3/31/2009

Enclosed please find my comments on the Interim Source Removal Action Work Plan (ISRAWP) of the Santa Susana Field Laboratory (SSFL). SOURCE REMOVAL is the only way we can guarantee a healthy future in the San Fernando and Simi Valley's.

Table 3-1
Source Removal Alternative Evaluation Matrix
(Page 1 of 1)

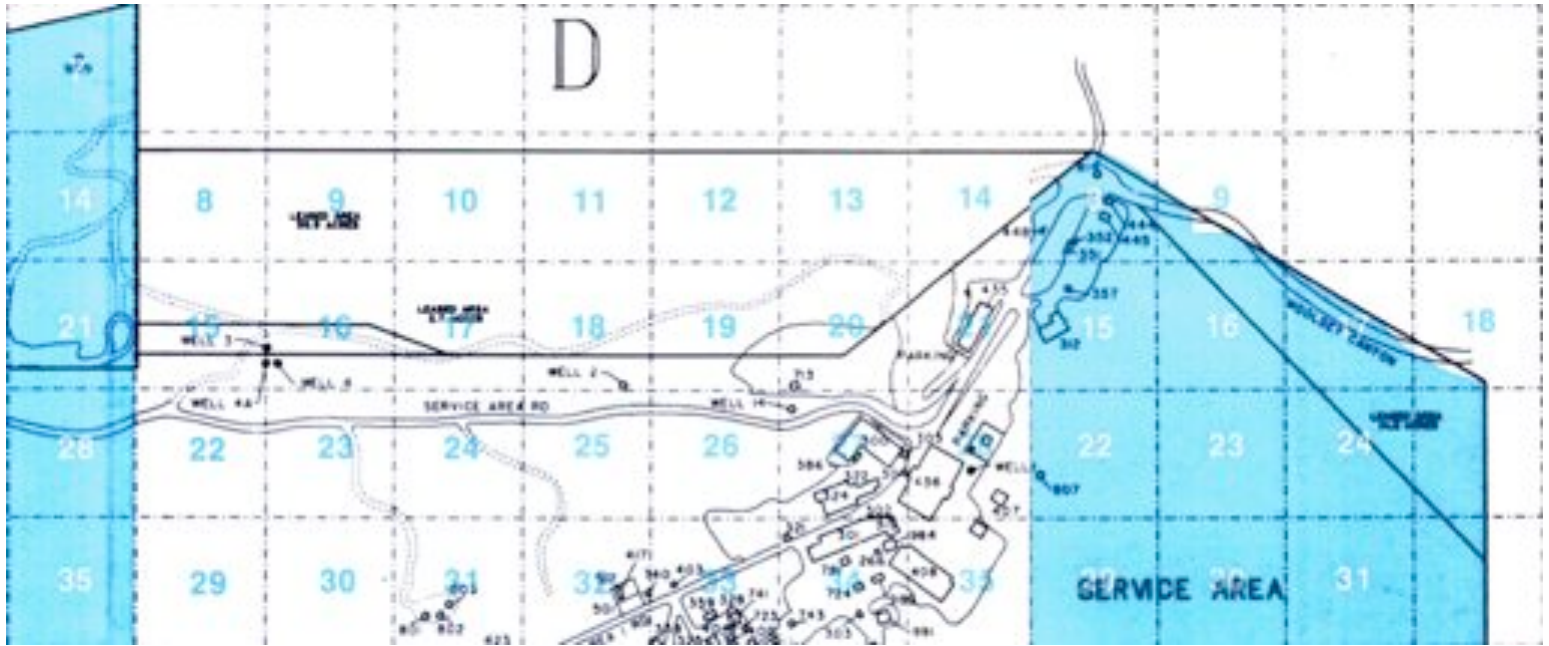
They are bringing in large pipes and installing them as we speak in a pre-emptive building of the ENTS. Is the Boeing Co. allowed to do this if the ENTS has not yet been approved?
